MEMO

To: Nathaniel Milam, P.E. (Whitson Engineers)
 From: Tarick Abu-Aly, P.E.
 Date: March 22, 2022

Subject: Addendum to Potential Impacts to the State Parks Barn Complex Due to the Carmel River Floodplain Restoration and Environmental Enhancement Project

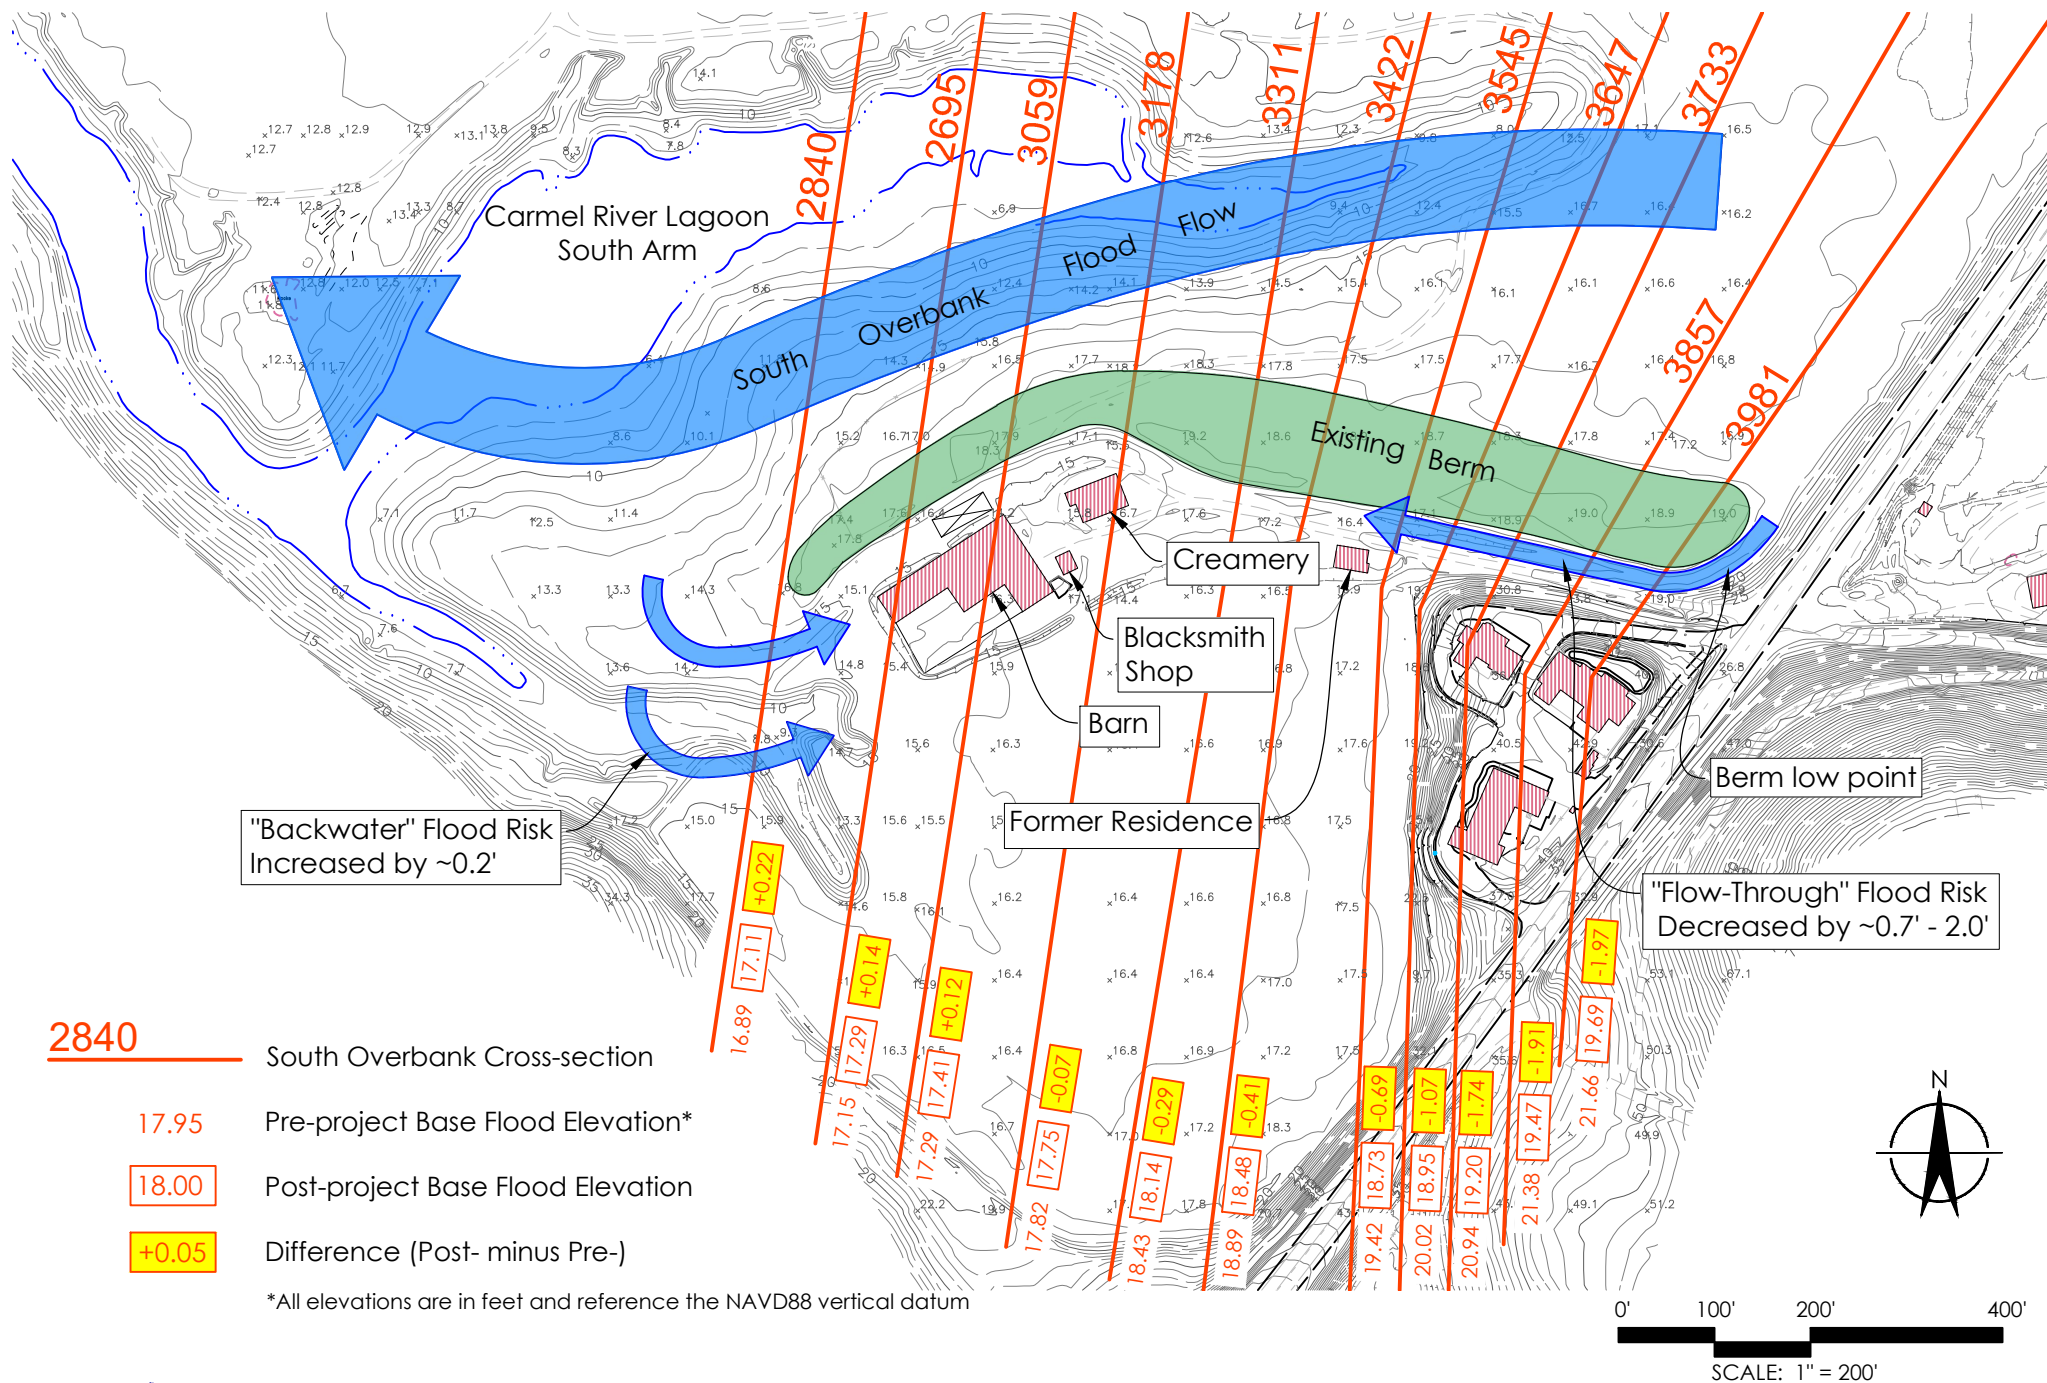
In September of 2016, Balance Hydrologics submitted a memo summarizing the potential impacts to the State Park Barn Complex located west of the proposed Highway 1 Causeway Bridge (**Attachment A**). The Base Flood Elevations (BFEs) published in the memo were based on hydraulic modeling of pre- and post-project conditions performed by Balance in 2015. Since then, Balance has kept the hydraulic model updated as the design plans have progressed. More recently in 2021, as part of an effort to obtain a Conditional Letter of Map Revision (CLOMR) from the Federal Emergency Management Agency (FEMA), the hydraulic model was revised based on minor design changes and comments received from FEMA. The revised pre- and post-project hydraulic models and associated BFEs have been tentatively approved by FEMA and, although we have not received the final CLOMR yet, the model results can be considered “draft final”.

As an addendum to the prior memo, we have updated **Table 1** and **Figure 1** to reflect the most recent modeled BFEs and revised target First Floor Elevations (FFE). Although the BFEs have changed slightly, the flood risk mitigation recommendations of the 2016 memo still apply.

Figure 1. 100-year flood risk assessment at the State Parks Barn Complex, Monterey County, California.

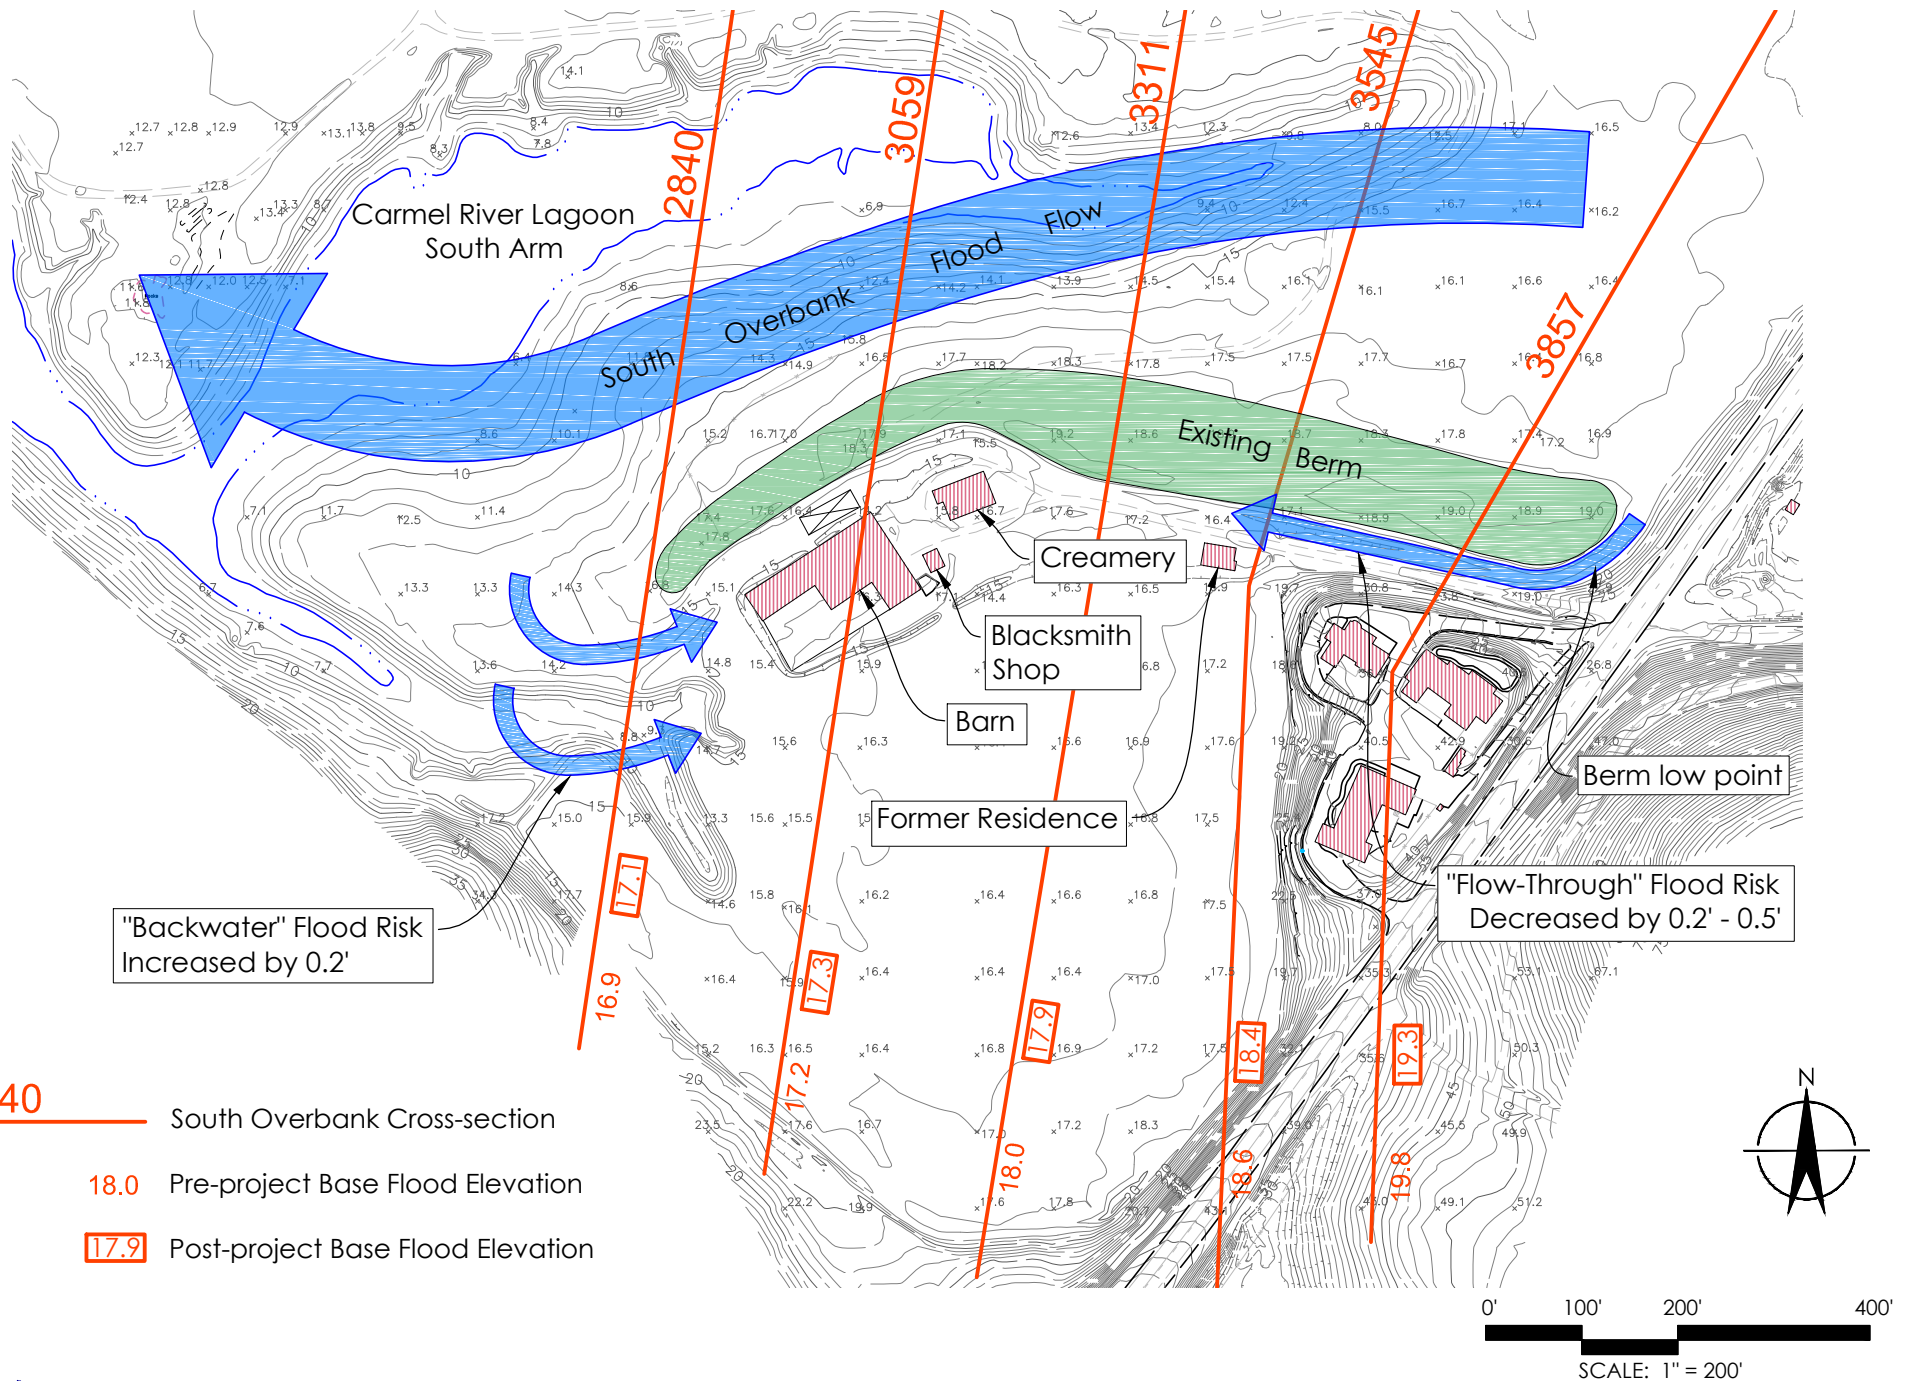
1. **Flow-Through Flooding Risk.** While the top of berm is, in general, above or just at the existing 100-year BFE, a low point exists near Highway 1 (see Figure 1). Under existing conditions, the modeled BFE at this low point is 19.8 feet compared to a low ground elevation of just under 18.0 feet based on best available topographic data. Actual flood elevations at the Barn Complex would be expected to be lower than this modeled elevation because the 100-year peak flow would likely not crest long enough and the low point would not be wide enough to equalize the water surface elevations on the inboard

While some water surface elevations are expected to decrease with the construction of the Causeway, all four properties would still be mapped in the FEMA 100-year floodplain unless substantial work is completed to convert the berm to a FEMA-certified levee with the appropriate freeboard and structural integrity. The pre- and post-project mapped BFEs are shown on the cross-sections in Figure 1.

Regardless of whether changes in the mapped risk are expected, the existing FFEs of the Barn, the Blacksmith Shop, and the Former Residence buildings are higher than both the pre- and post-project BFEs³. These FFEs are also higher than the pre- and post-project backwater elevations of 16.9 and 17.1 feet, respectively. Without improvements to the berm, the buildings are still subject to flow-through flooding, but the risk is reduced in the post-project scenario as the flood elevation at the low point in the berm decreases from 19.8 to 19.3 feet. Therefore, the CRFREE
